DELAWARE DEPARTMENT OF TRANSPORTATION	ADDENDUMS / REVISIONS	NOT TO SCALE	SR1 / I-95 INTERCHANGE	CONTRACT 28-090-03	BRIDGE NO.	TYPICAL SECTIONS	SHEET NO. 10
	ADDENDUM NO. 3 CHANGED ITEM NO., 02/18/2011, RLS			COUNTY NEW CASTLE	DESIGNED BY:		TOTAL SHTS. 803
					CHECKED BY:

DELAWARE DEPARTMENT OF TRANSPORTATION	ADDENDUMS / REVISIONS ADDENDUM NO. 3 CHANGED ITEM NO., ADDED O.H. SIGN REMOVAL, 02/18/2011 RLS	SCALE 0 50 100 150 FEET	SR1 / I-95 INTERCHANGE	CONTRACT 28-090-03 COUNTY NEW CASTLE	BRIDGE NO. DESIGNED BY: CHECKED BY:	CONSTRUCTION PLAN

DELAWARE DEPARTMENT OF TRANSPORTATION	ADDENDUMS / REVISIONS: ADDENDUM NO. 3 VOIDED SHEET; MODIFIED ITMS DESIGN SEE SHEET 711A, 02/18/2011, JCR	SCALE 0 50 100 150 FEET	SR1 / I-95 INTERCHANGE	CONTRACT 28-090-03; COUNTY NEW CASTLE; BRIDGE NO.; DESIGNED BY:; CHECKED BY:	SIGNING, STRIPING & CONDUIT PLAN; SSC-1; SHEET NO. 711; TOTAL SHTS. 803

ADDENDUMS / REVISIONS	
ADDENDUM NO. 3 THIS SHEET 713A	
REPLACES VOIDED SHEET 713	
02/18/2011, JCR

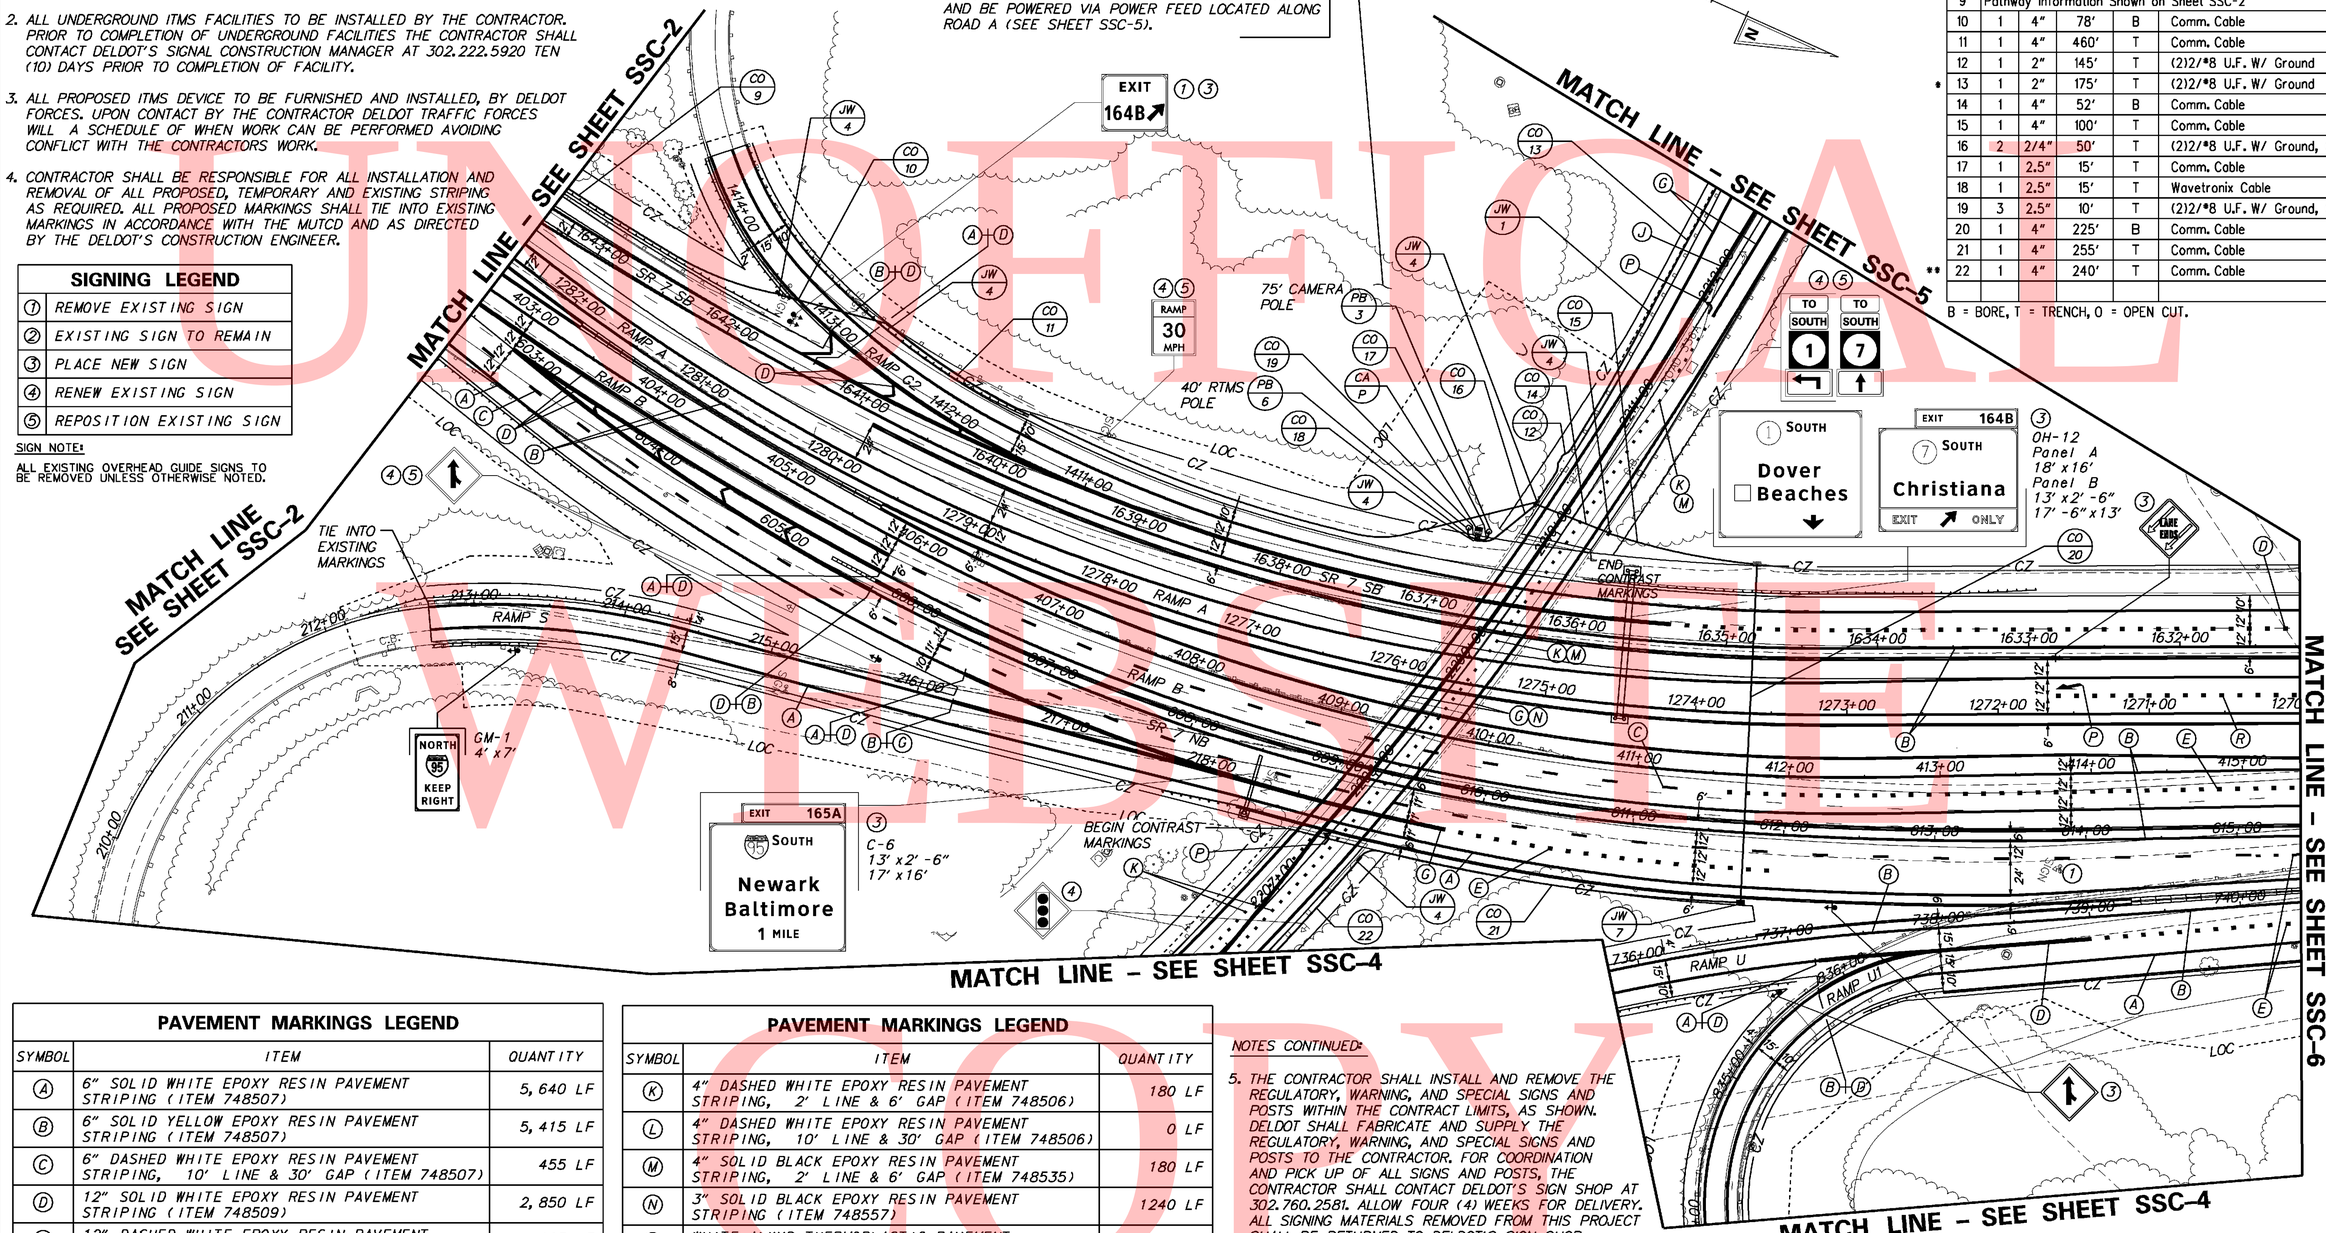
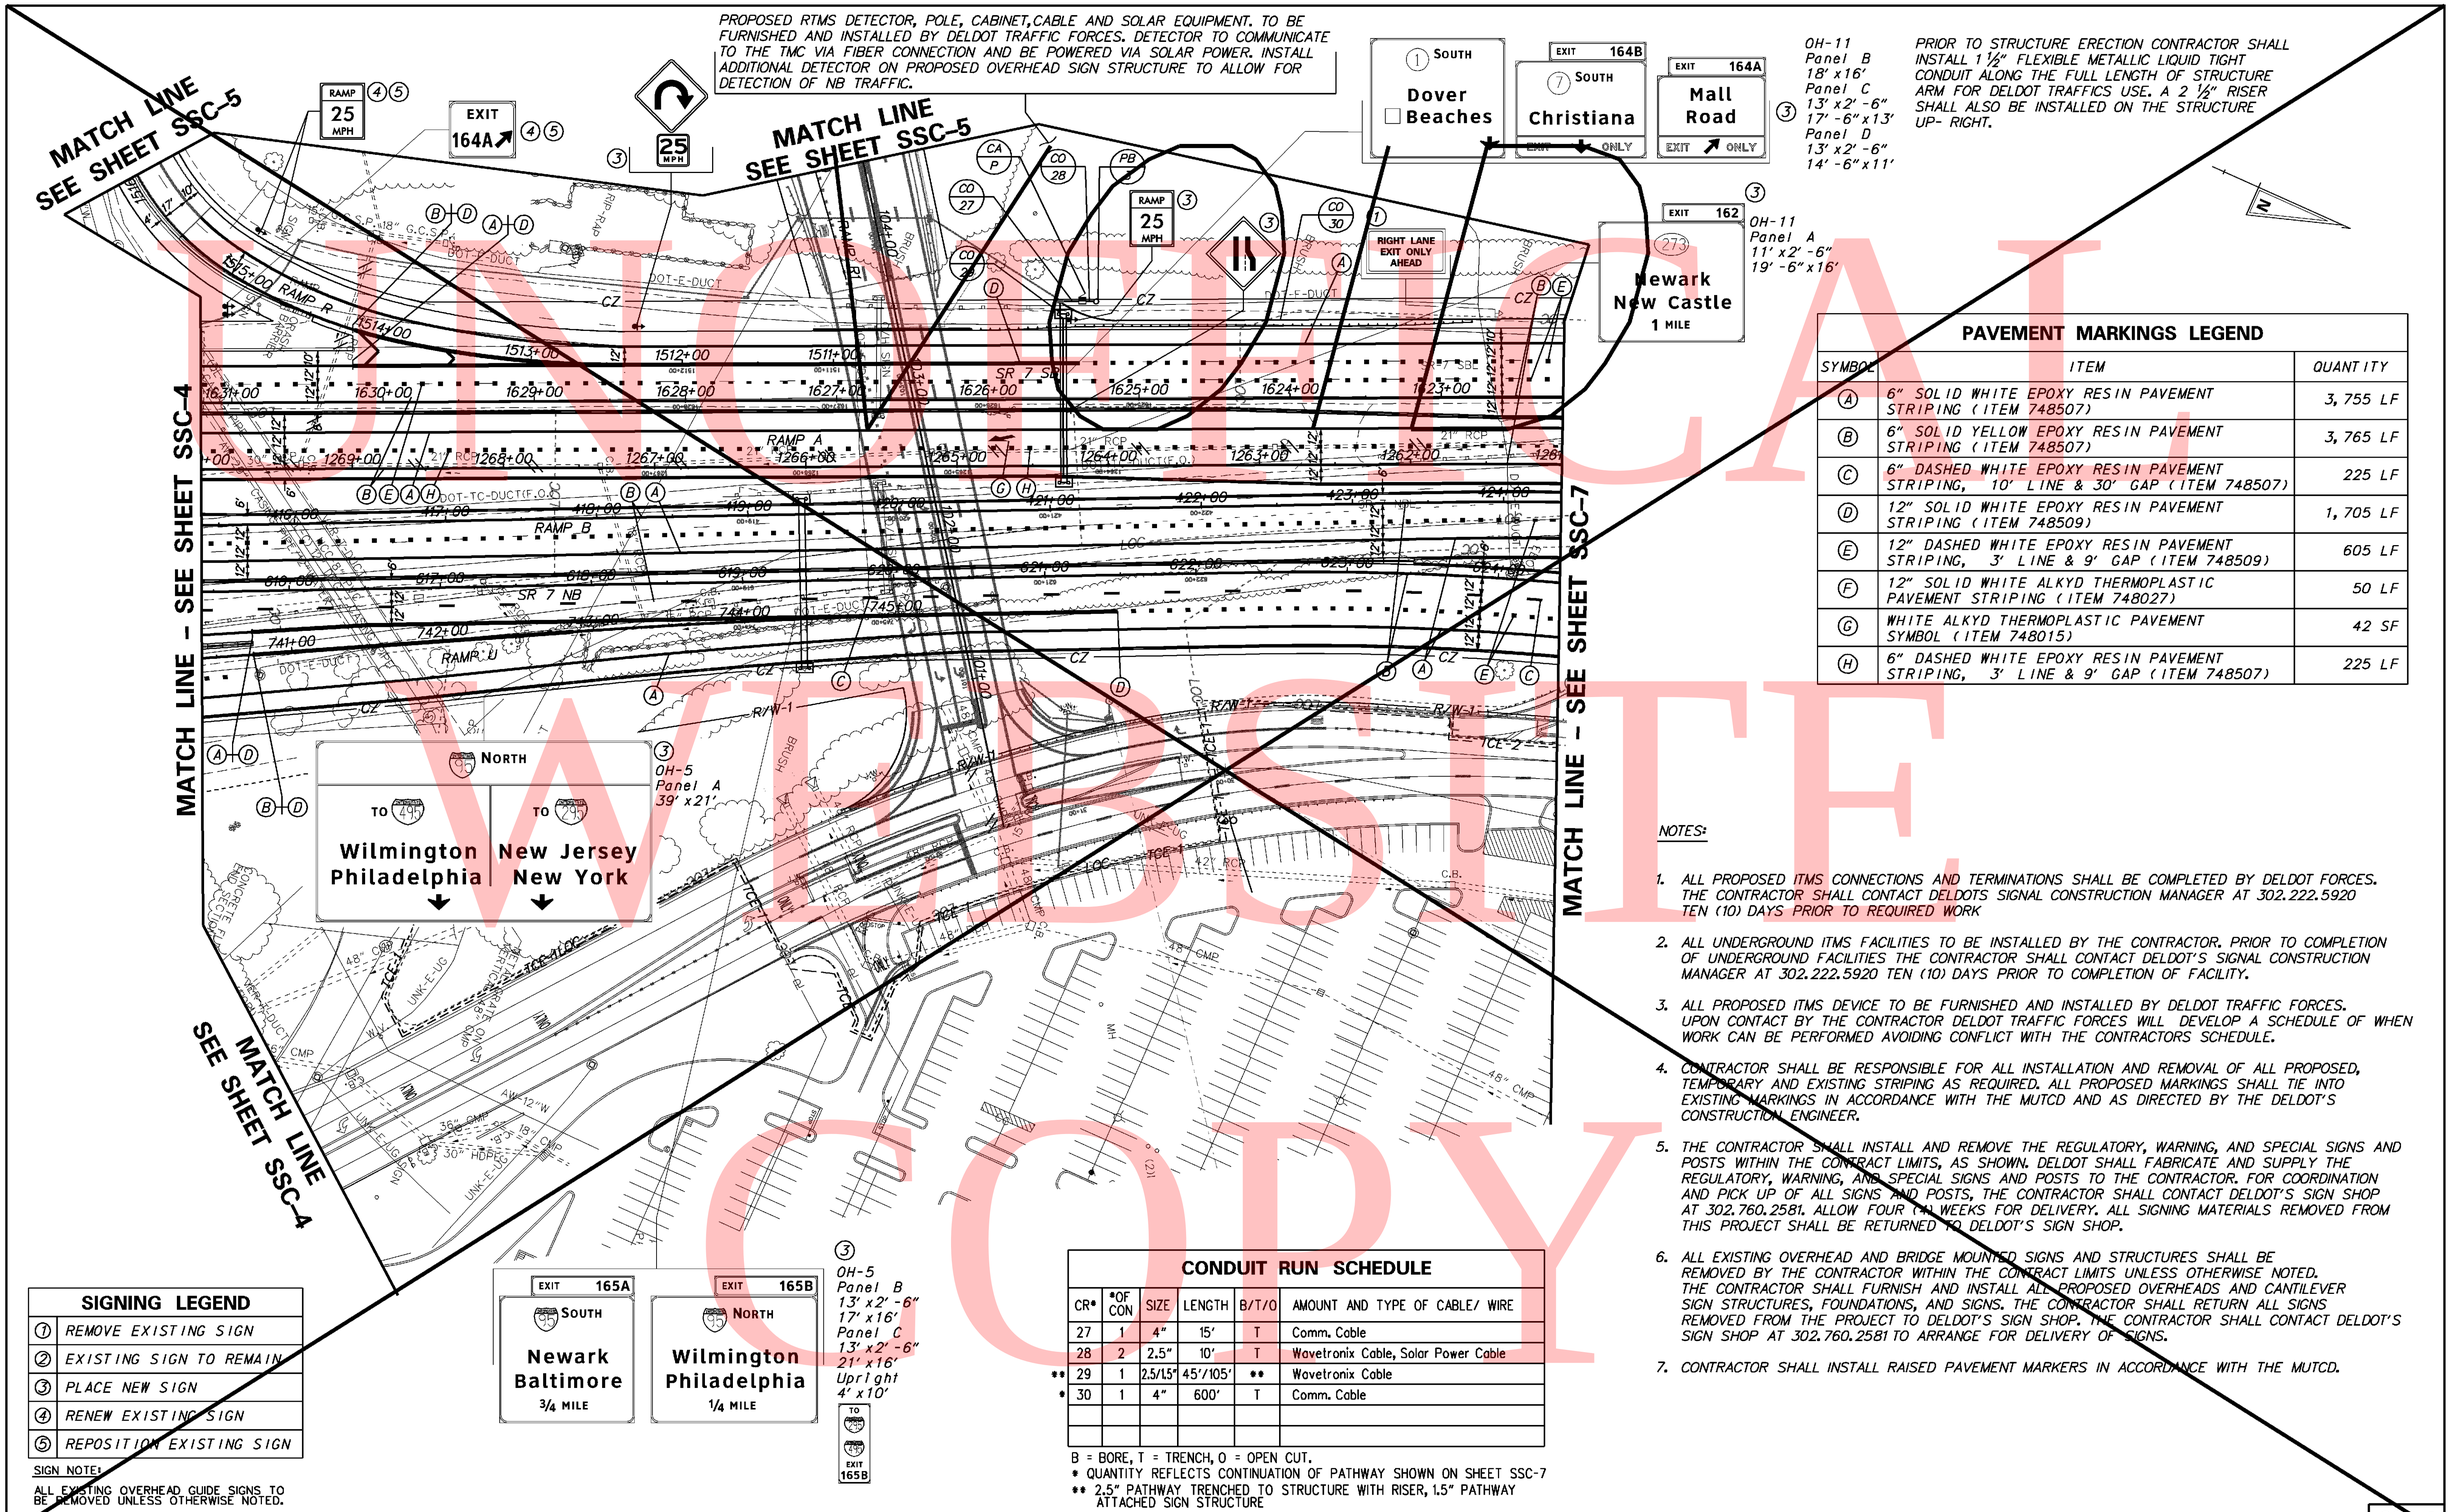
ADDENDUMS / REVISIONS	
ADDENDUM NO. 2 VOIDED SHEET	
MODIFIED ITMS DESIGN SEE SHEET 713A,	
02/18/2011, JCR

ADDENDUMS / REVISIONS	
ADDENDUM NO. 3 THIS SHEET 716A	
REPLACES VOIDED SHEET 716	
02/18/2011, JCR

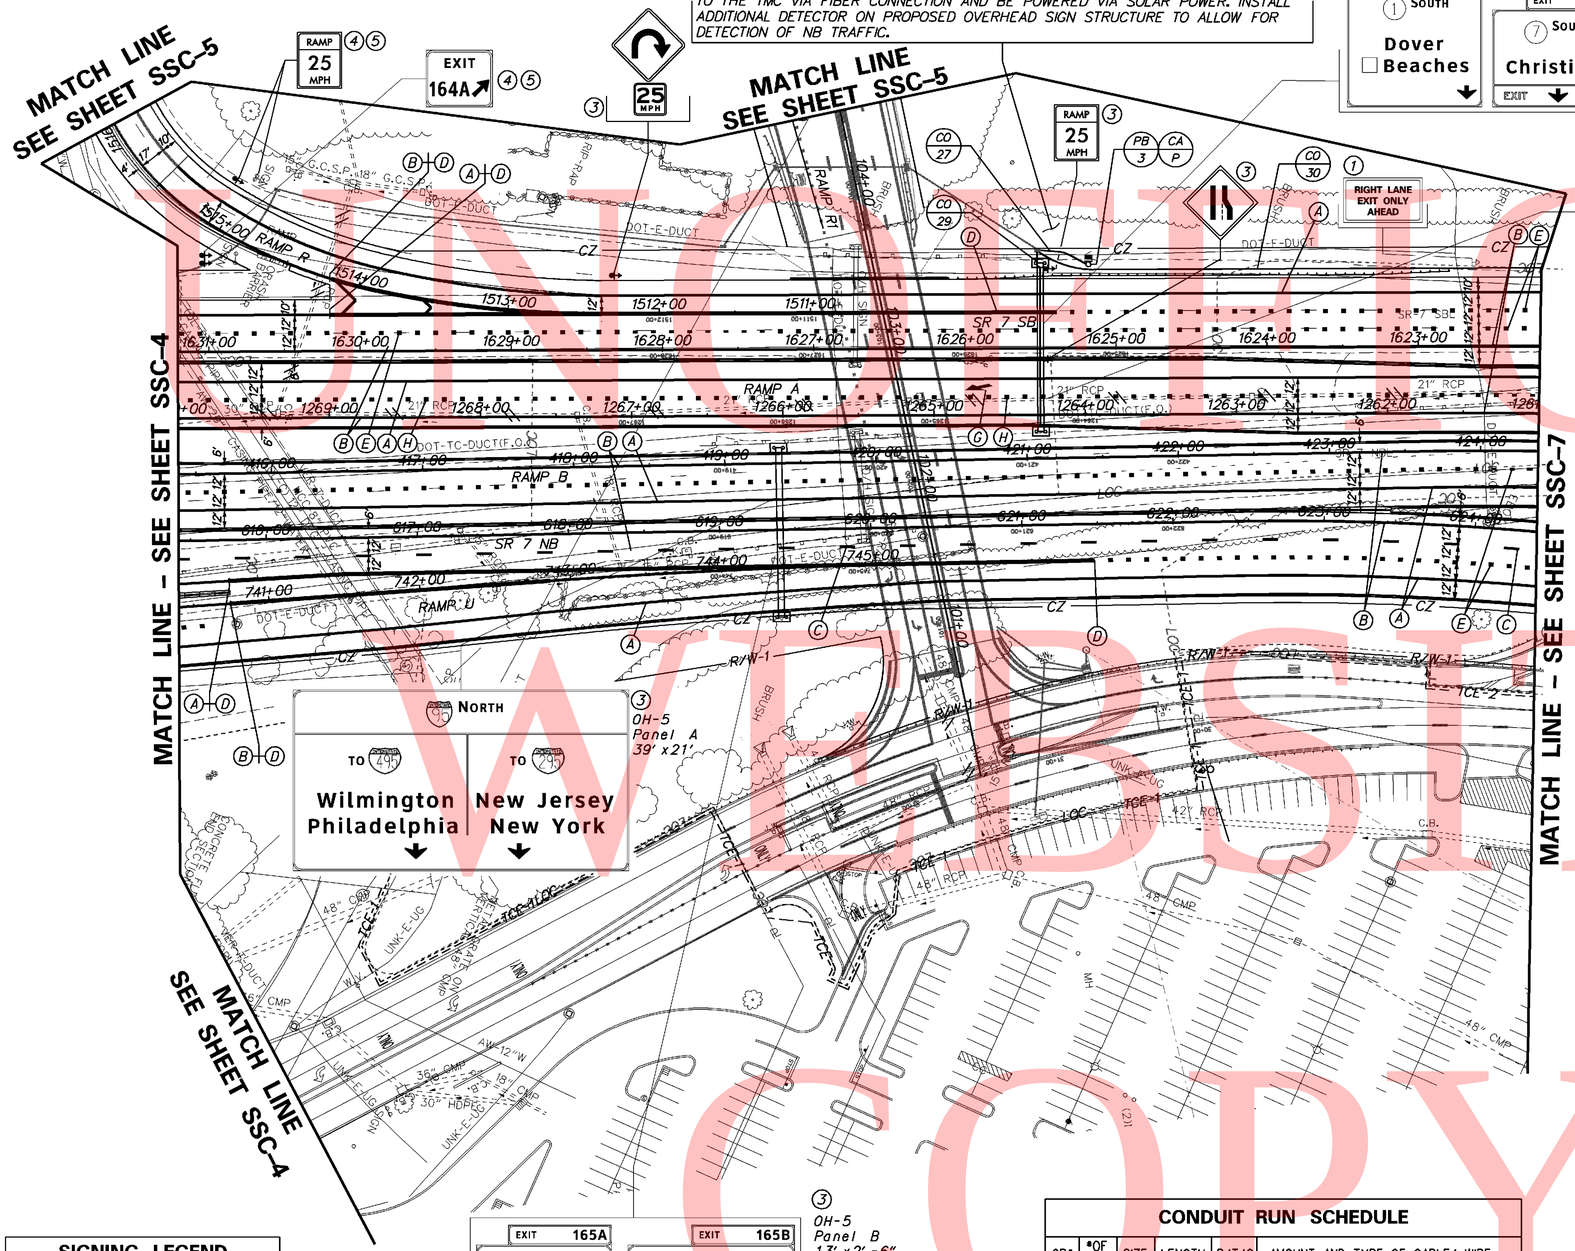
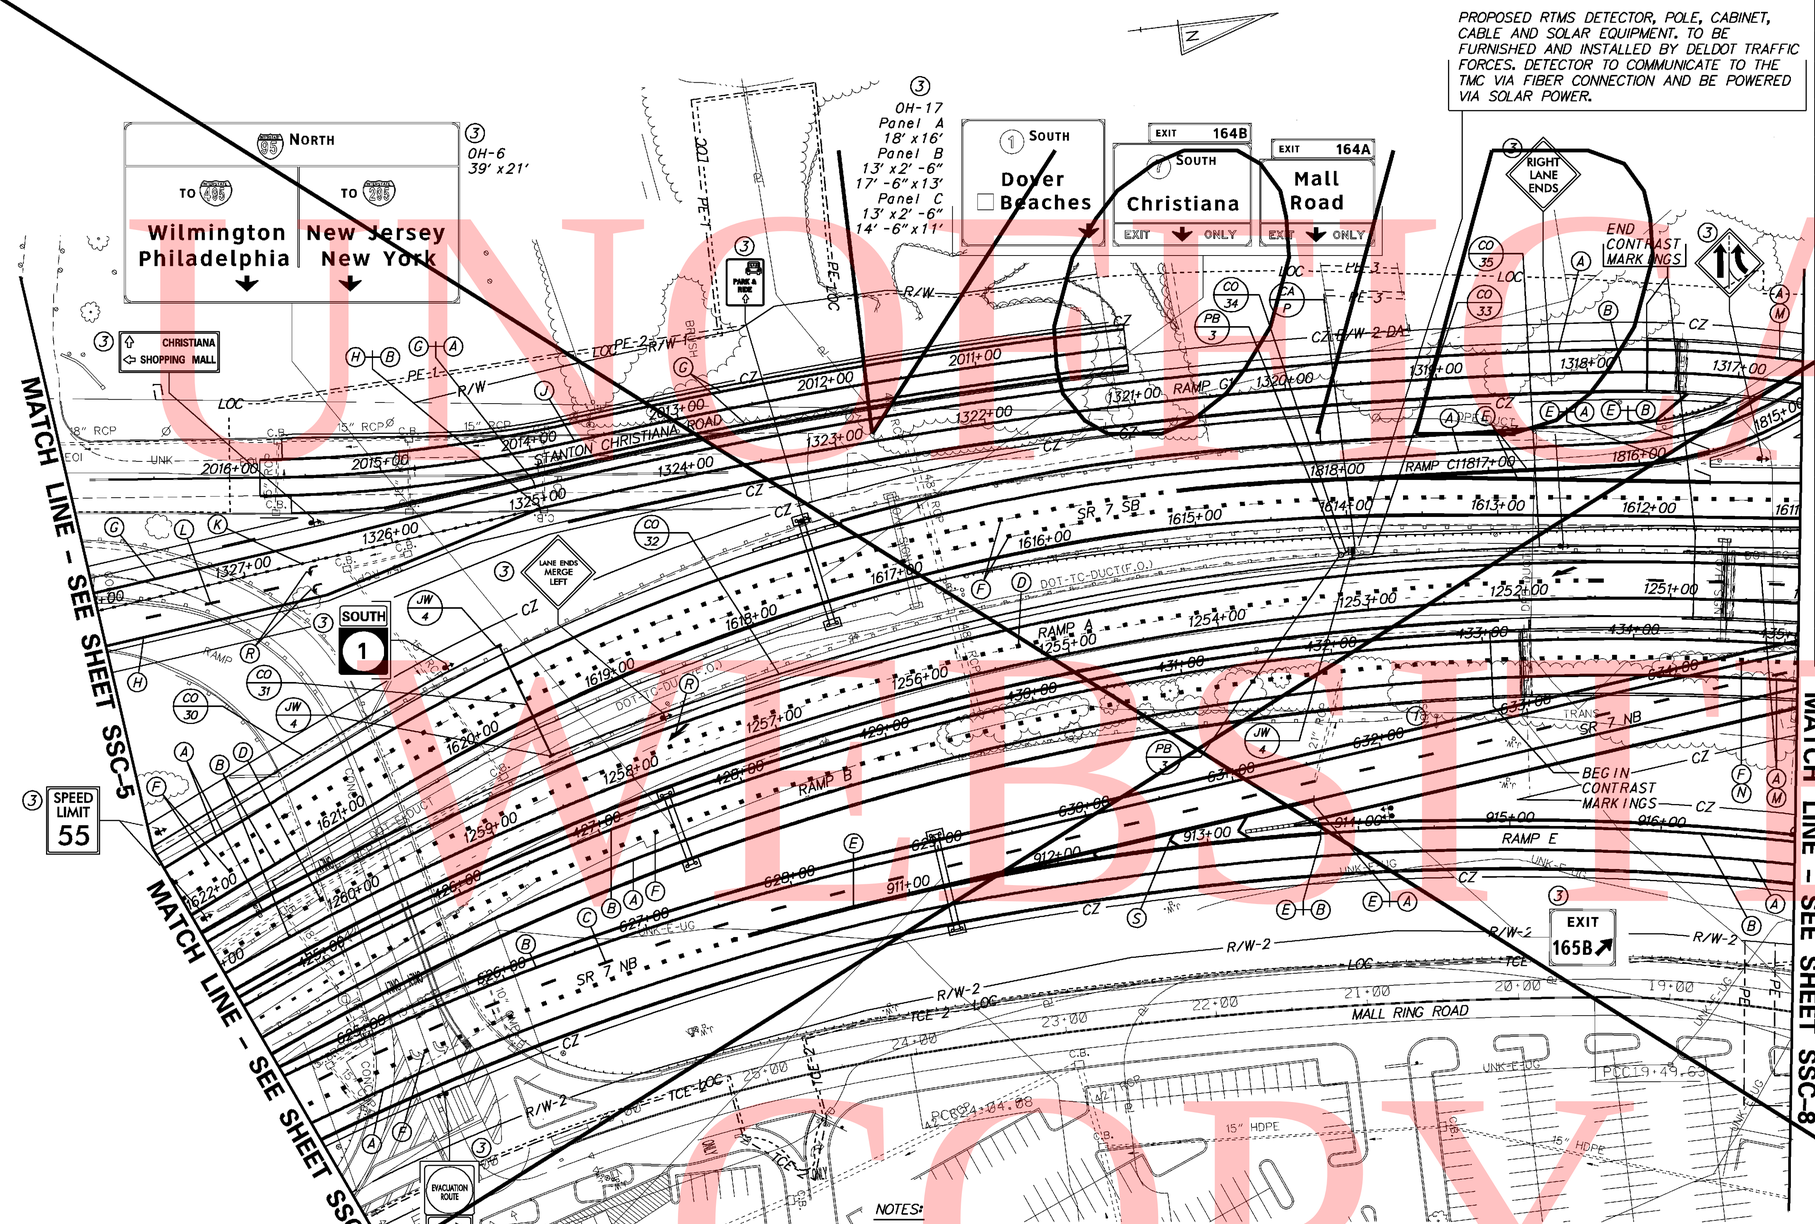
ADDENDUMS / REVISIONS	
ADDENDUM NO. 3 VOIDED SHEET	
MODIFIED ITMS DESIGN SEE SHEET 716A,	
02/18/2011, JCR

PRIOR TO STRUCTURE ERECTION CONTRACTOR SHALL INSTALL 1 ½" FLEXIBLE METALLIC LIQUID TIGHT CONDUIT ALONG THE FULL LENGTH OF STRUCTURE ARM FOR DELDOT TRAFFICS USE. A 2 ½" RISER SHALL ALSO BE INSTALLED ON THE STRUCTURE UP- RIGHT.
